May 12, 2015
Medway Planning and Economic Development Board
155 Village Street
Medway, MA 02053

Tri Valley Common – Public Hearing Continuation:

RE: TRI VALLEY COMMONS SITE PLAN
DRC INTERIM LETTER OF RECOMMENDATION REVIEW

PROPOSED EXTERIOR ELEVATIONS
RETAIL BUILDING "A"
TRI VALLEY COMMONS
MEDWAY, MA

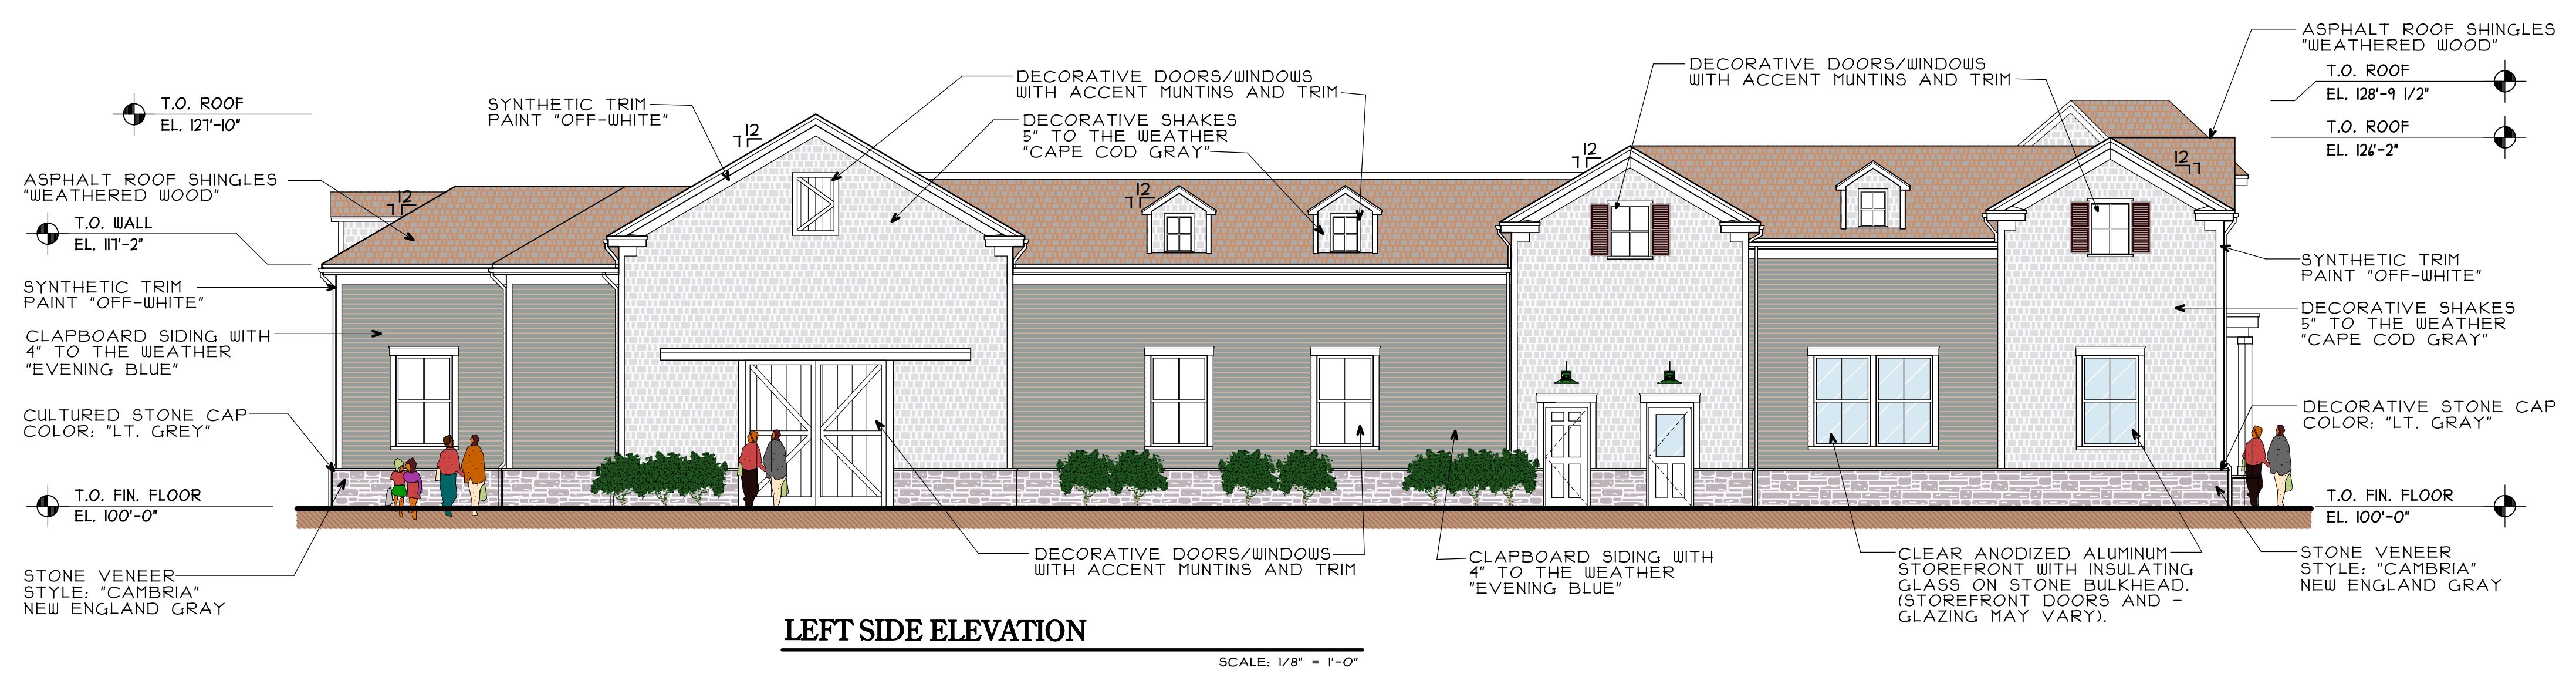
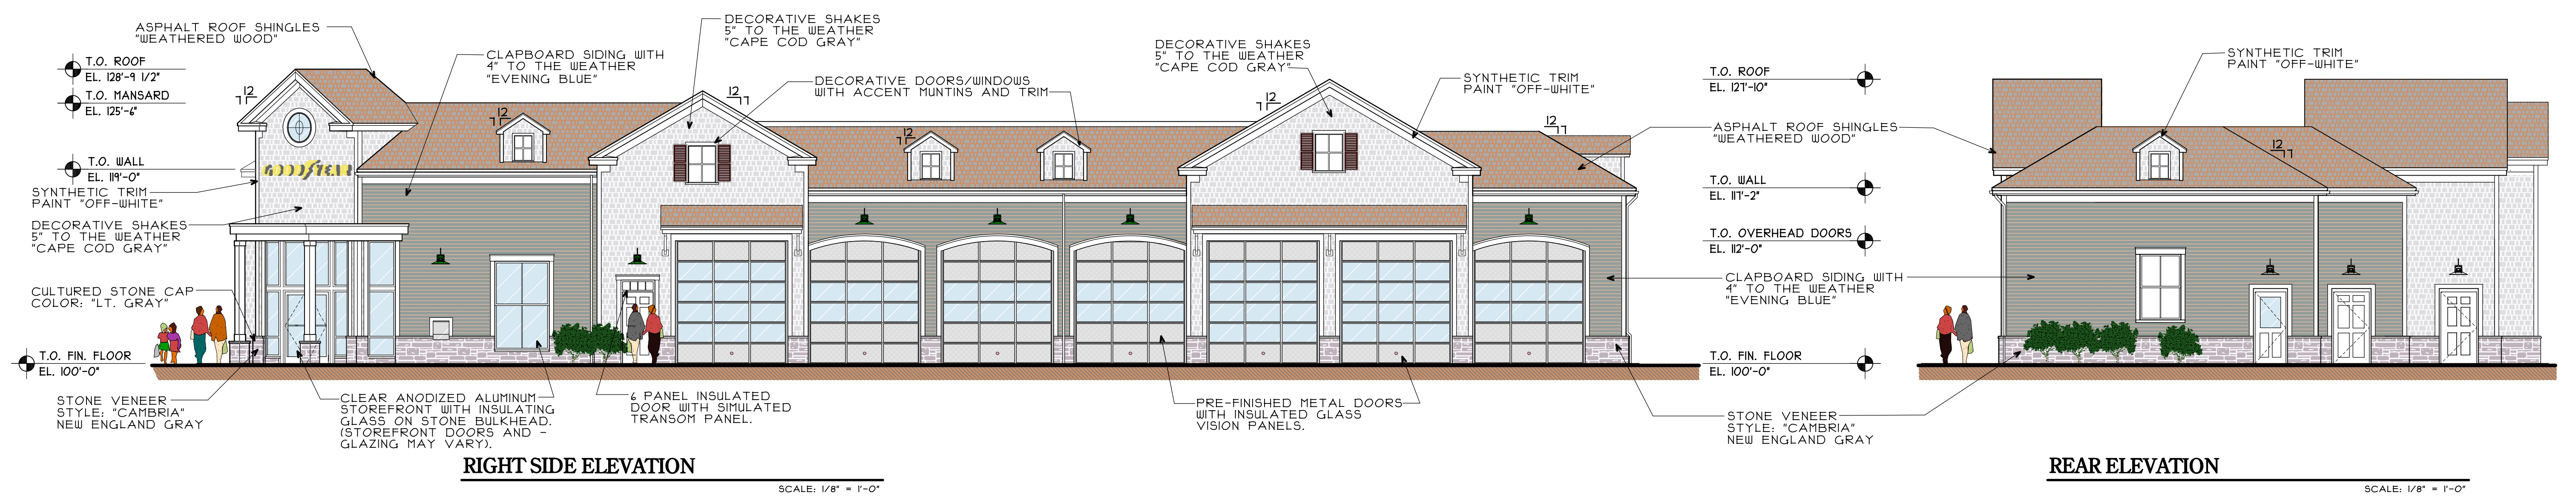
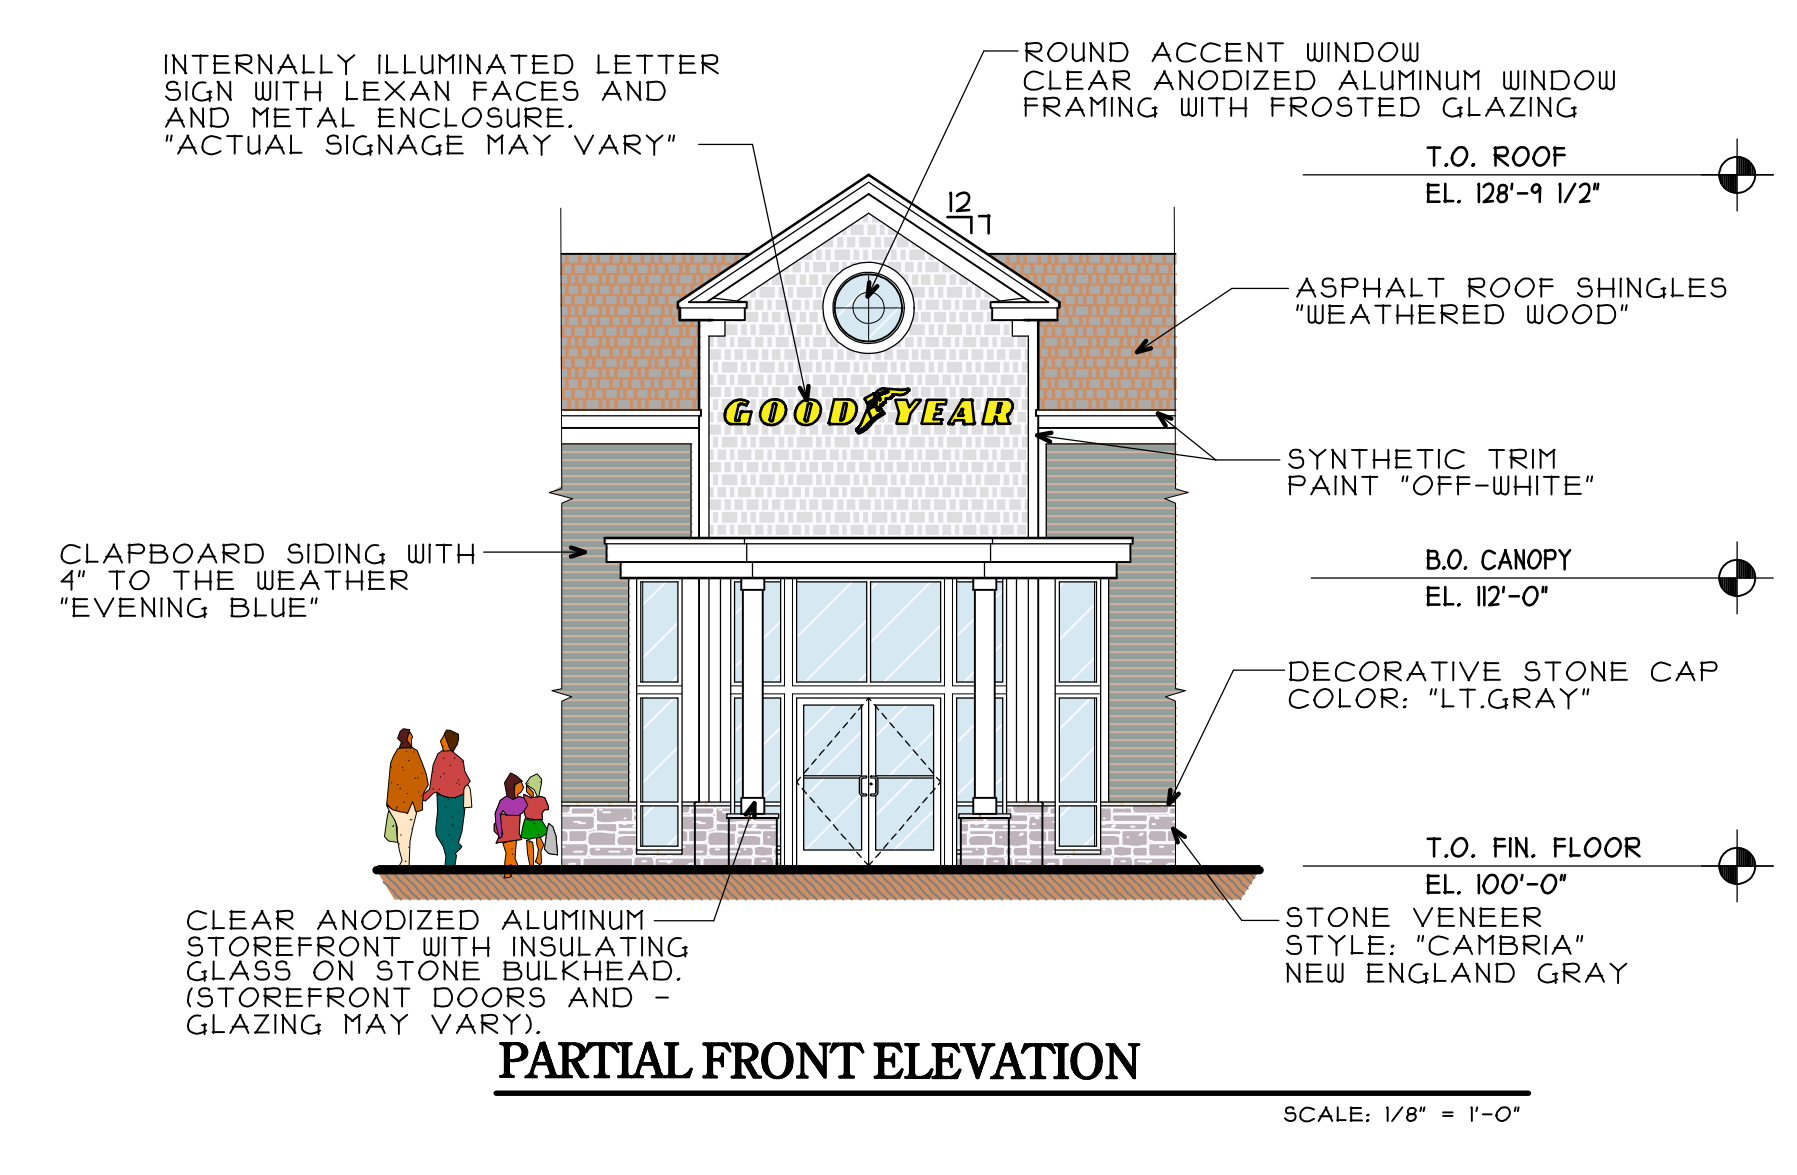
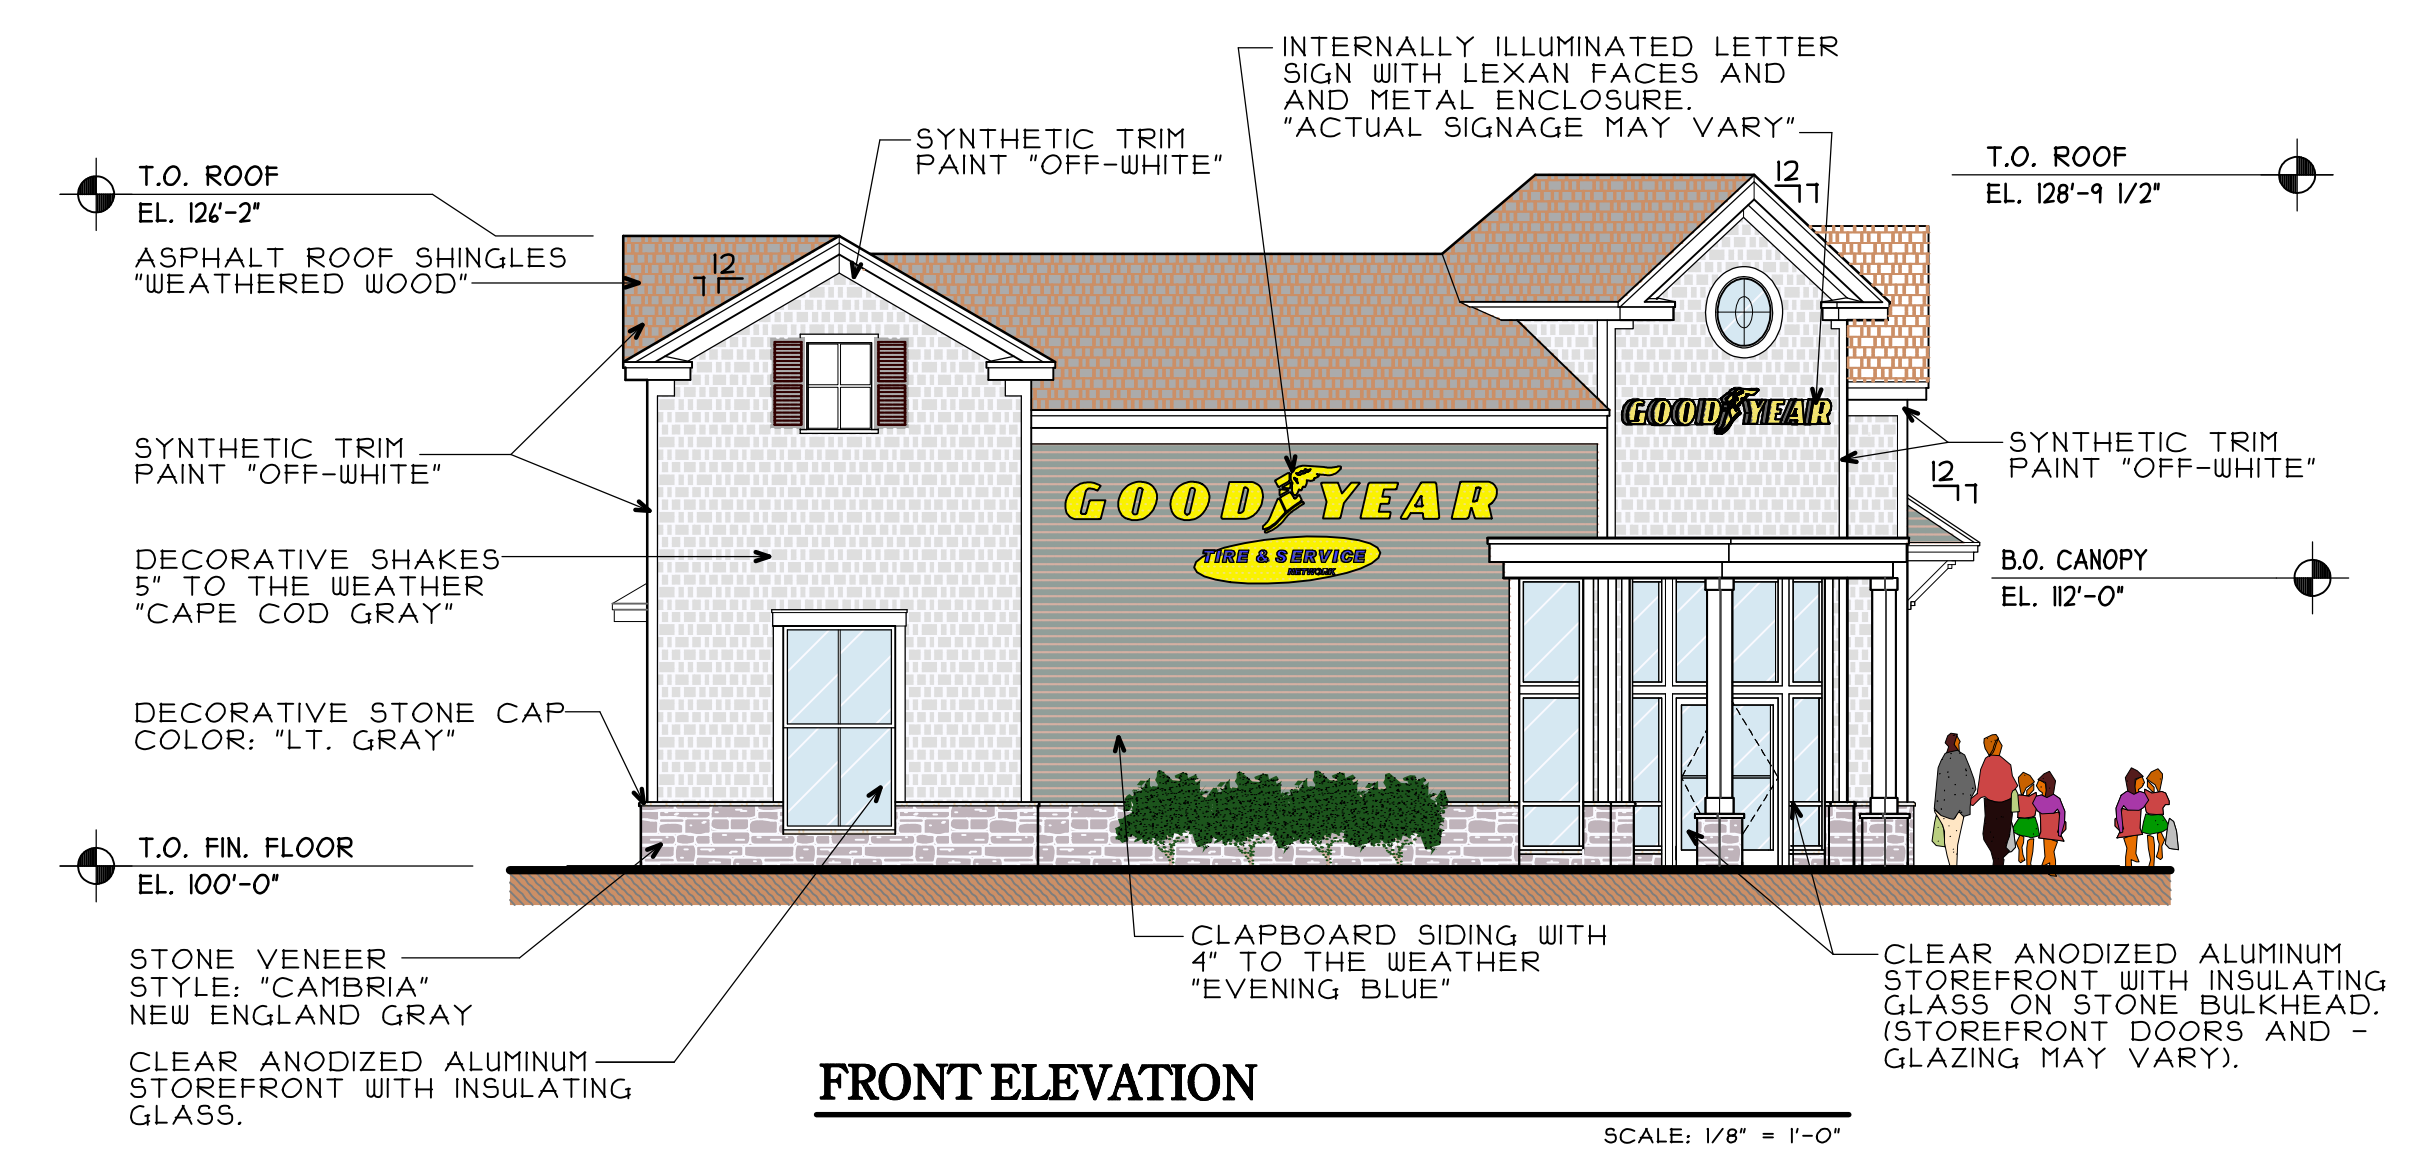
An inconsistency was noted among the site plan elevation sheets with regard to the description of the stone veneer to be used as a water table. The DRC would like to clarify and recommend:

- That the stone veneer be a consistent material in what the plans call “Cambria New England Grey”
- The DRC recommends that the stone veneer be variegated with rounded units that reflect indigenous fieldstone.
